# HISTORIC AND DESIGN REVIEW COMMISSION

June 18, 2025

**HDRC CASE NO:** 2025-151  
**COMMON NAME:** 1702 BROADWAY  
**ADDRESS:** 1602 BROADWAY  
1606 N ALAMO  
1611 N ALAMO  
1613 N ALAMO  
**LEGAL DESCRIPTION:** NCB 1765 (BESA), LOT 21  
NCB 965 BLK LOT 22, 23 & 24 NCB 984 BLK LOT 33, 34 & 35  
**ZONING:** IDZ-3, H  
**CITY COUNCIL DIST.:** 2  
**APPLICANT:** Mark Henderson/Ford Powell and Carson  
**OWNER:** BESA LAND PARTNERS LP  
**TYPE OF WORK:** Construction of a mixed-use development, relocation of a historic structure  
**APPLICATION RECEIVED:** May 30, 2025  
**60-DAY REVIEW:** July 29, 2025  
**CASE MANAGER:** Edward Hall

The applicant is requesting a Certificate of Appropriateness for approval to:

# Phase I • Lighting Plans

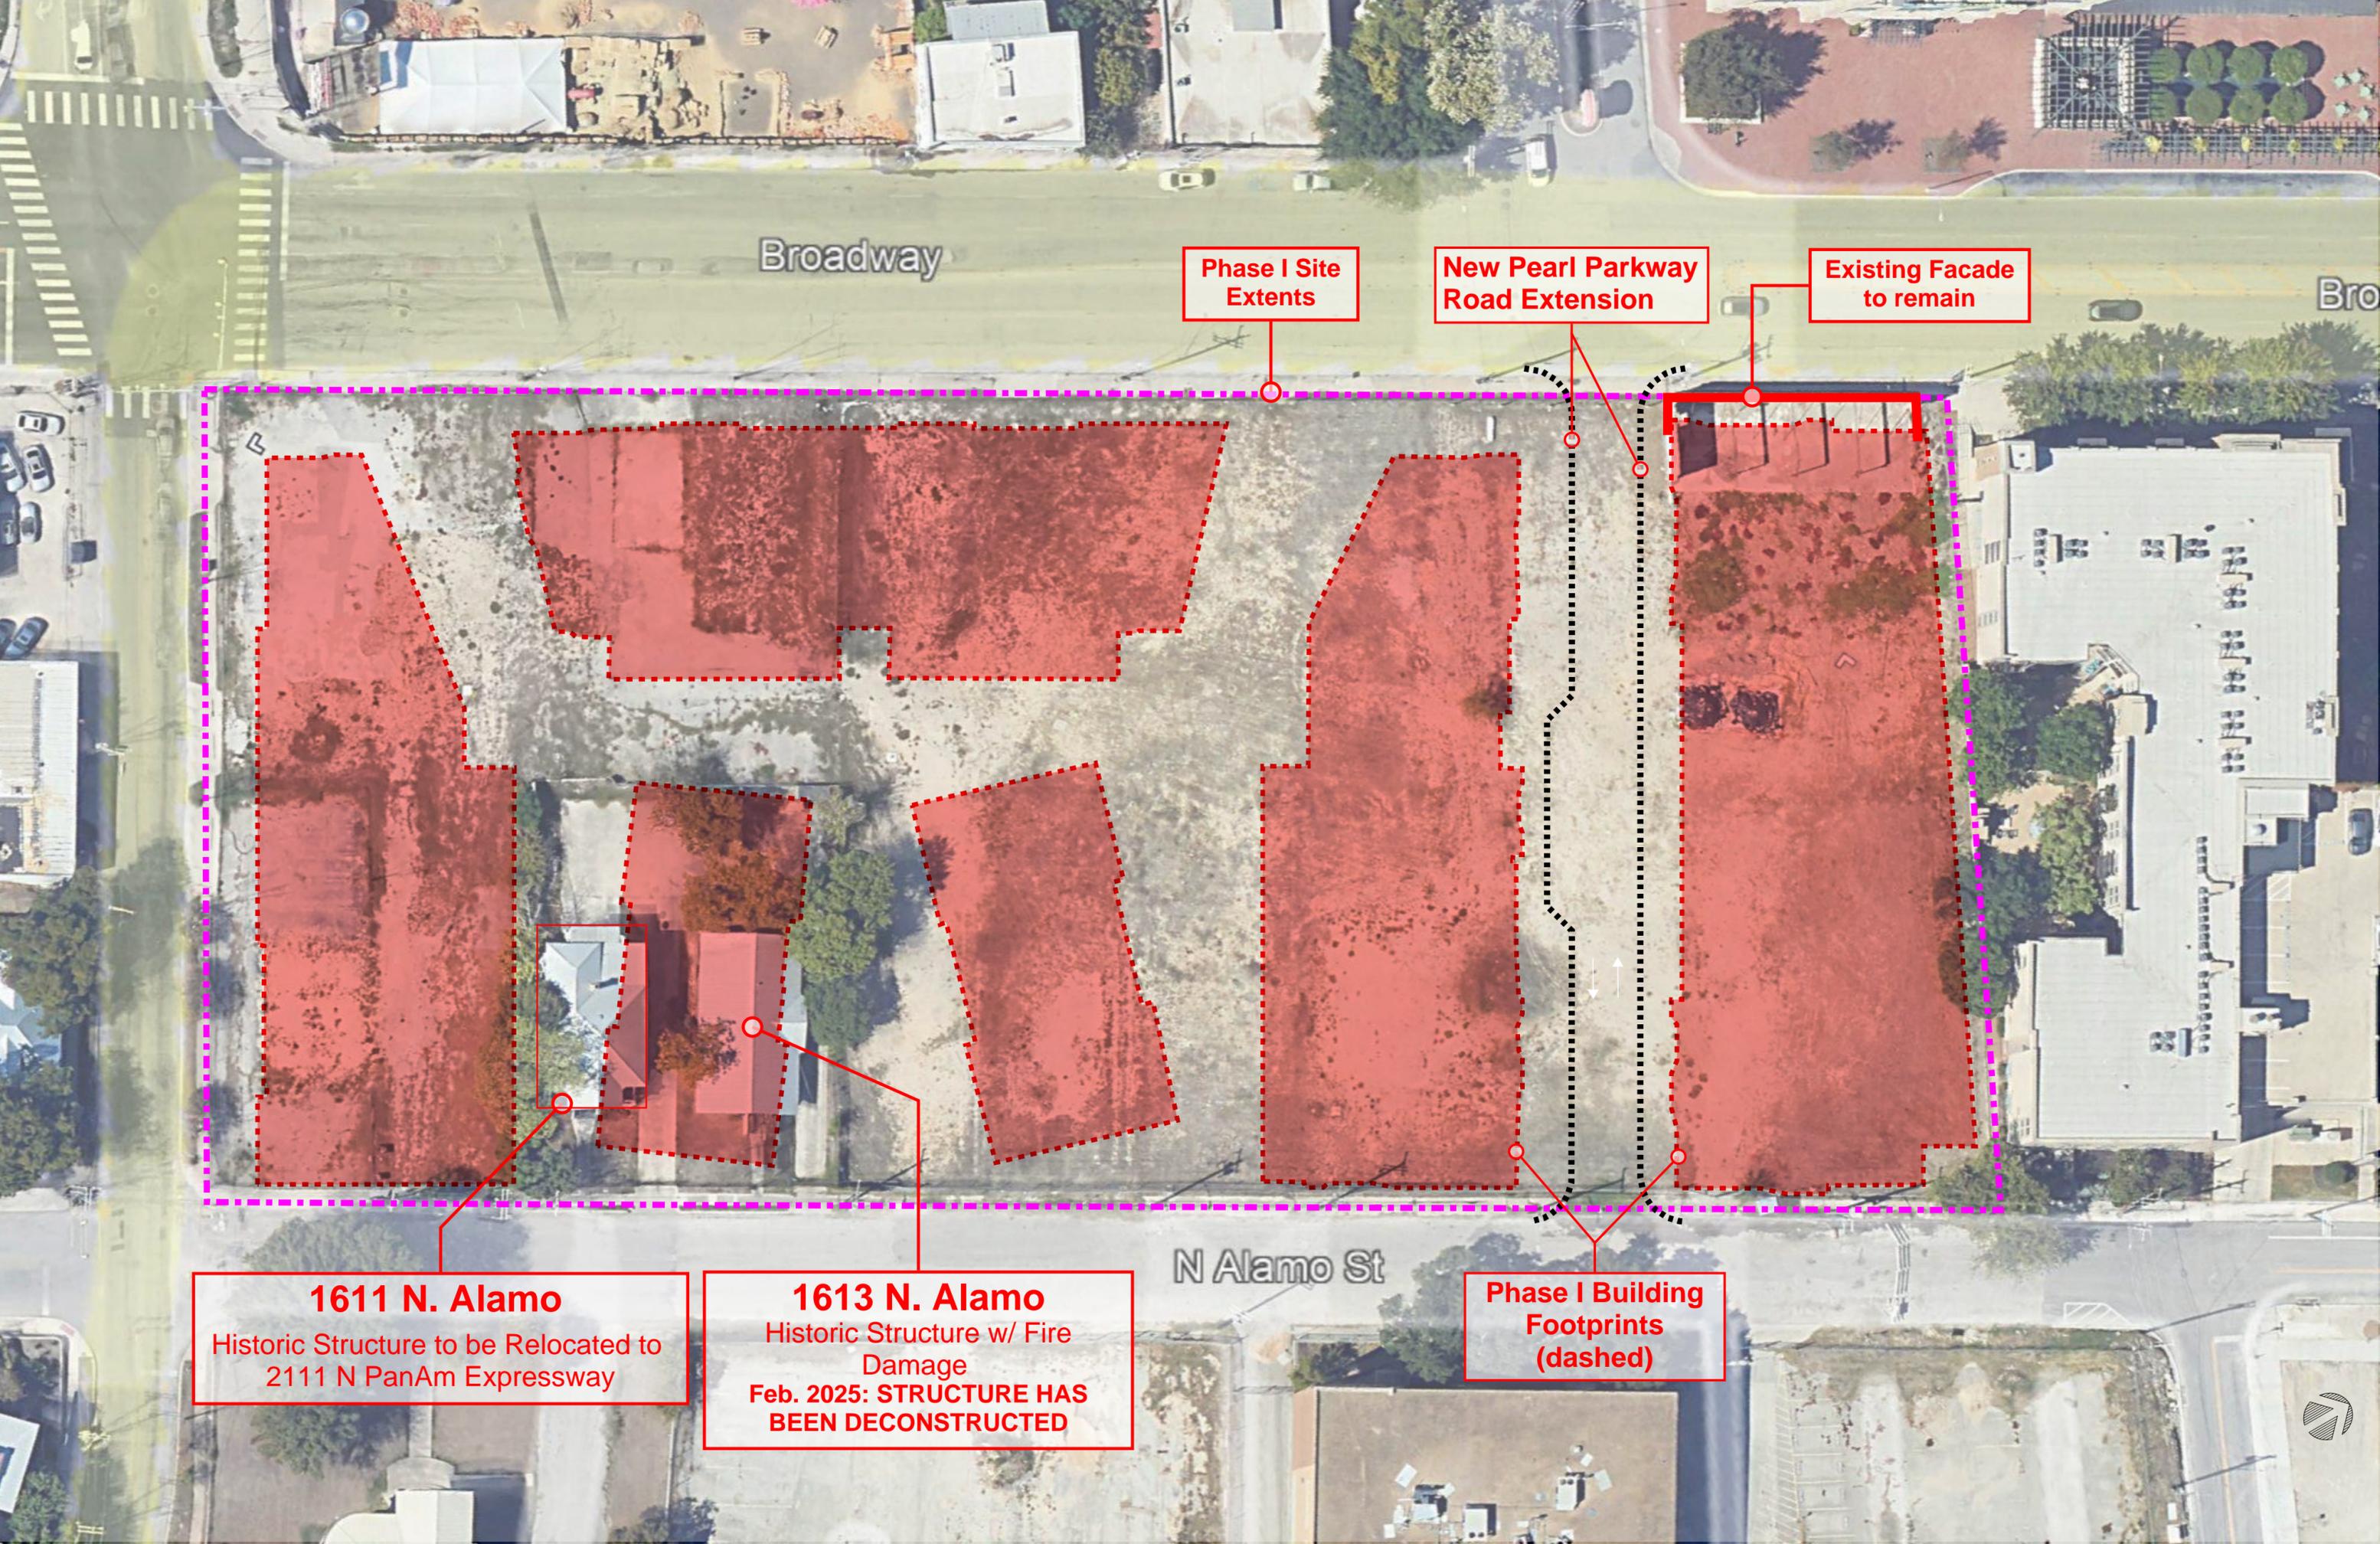
- q. LIGHTING DESIGN – Lighting design for any project located in a RIO district is an important aspect of not only that particular project’s design, but also the adjacent buildings as well as the River Walk. According to the UDC Section 35-673(j), site lighting should be considered an integral element of the landscape design of a property. The applicant has provided a lighting plan for architectural and landscaping elements. Staff finds the proposed lighting plan to be appropriate and consistent with the UDC.

- vi. That both architectural and landscape lighting plans be submitted for review and approval prior to returning to the Commission for final approval. ***This stipulation has been met.***

**Relocation Plan**

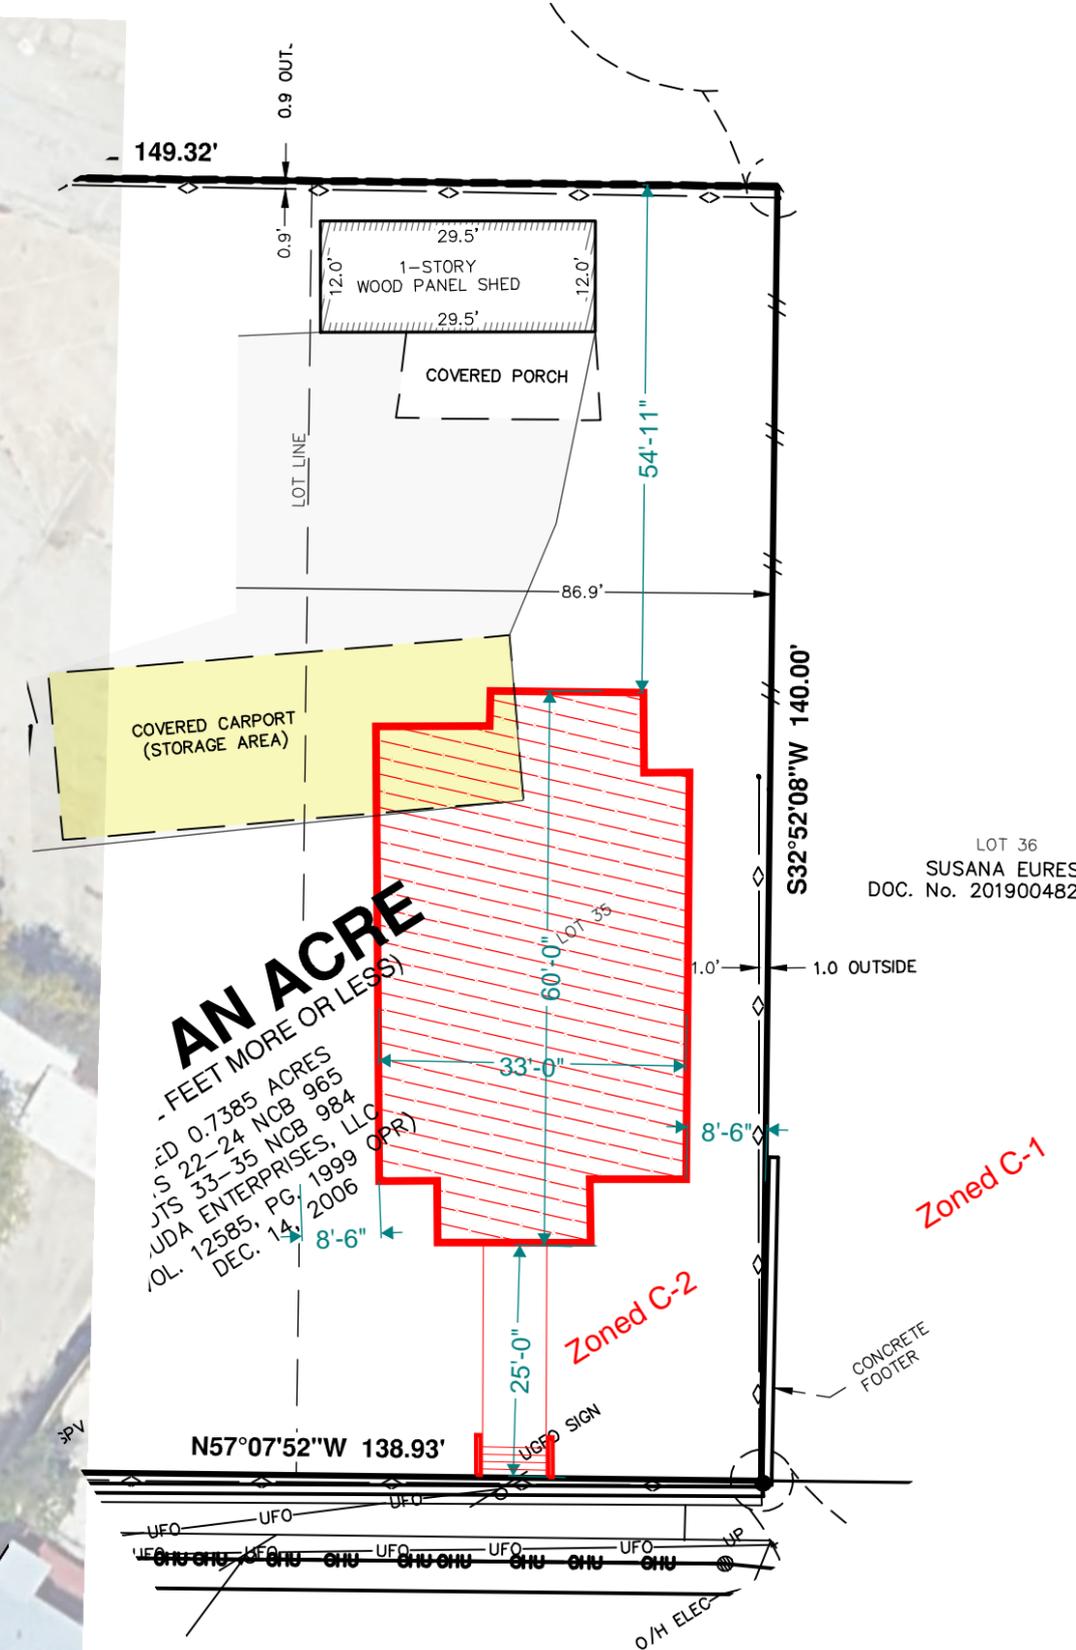
- d. RELOCATION – The applicant has proposed to relocate the 2-story, historic structure to the lot at 1606 N Alamo, an individually designated property. The UDC Section 35-613 provides guidance for the relocation of a historic structure. Per this section, the Historic and Design Review Commission shall be guided by the following considerations: 1) the historic character and aesthetic interest the building contributes its present setting; 2) whether there are definite plans for the area to be vacated and what the effect of those plans on the character of the surrounding area will be; 3) whether the building can be moved without significant damage to its physical integrity; 4) whether the proposed relocation area is compatible with the historical and architectural character of the building; and 5) balancing the contribution of the property to the character of the historic district with the special merit of the application. Generally, staff finds the relocation of the structure to this property to be appropriate given its close proximity to the original location. Prior to receiving a Certificate of Appropriateness, staff finds that the applicant should submit a detailed construction document set for this structure. The construction document set should include the cataloging of decorative architectural elements and building components and a detailed plan for the physical relocation and any associated deconstruction or disassembly of the structure to facilitate the proposed relocation.

- i. That the applicant submits a detailed construction document set for this structure. The construction document set should include the cataloging of decorative architectural elements and building components and a detailed plan for the physical relocation and any associated deconstruction or disassembly of the structure to facilitate the proposed relocation.

- i. That the relocation location for the historic structure at 1611 N Alamo be determined prior to returning to the Commission for final approval of the proposed new construction. These details should include a detailed construction document set, the cataloging of decorative architectural elements and building components and a detailed plan for the physical relocation and any associated deconstruction or disassembly of the structure to facilitate the proposed relocation. The new location must also be designated by the owner as a local historic landmark. ***This stipulations has been partially met.***
